Technical change to FTA-C300

PCN-number: 20220524
This document has indefinite validity from today

DEKAFIX detail

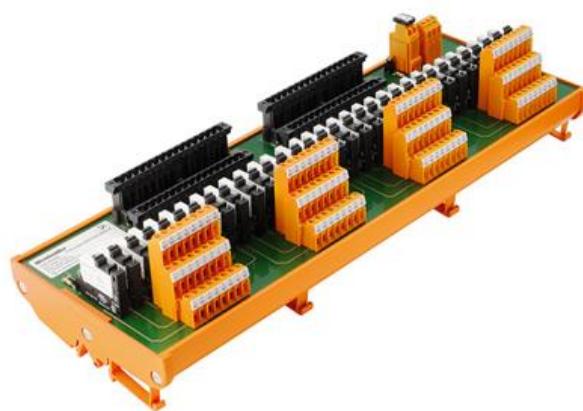
Articles on Section 5 were delivered in the past with LP and LP2N connectors. Furthermore, they were delivered with Dekafix*

*Dekafix is the universal marker for terminals, plug-in connectors and electronic modules from the Weidmüller product range (see detail).

Based on continuous improvement the LP, LP2N and LP3R connectors will be respectively replaced by LL, LL2N and LL3R connectors with Tampoprint.
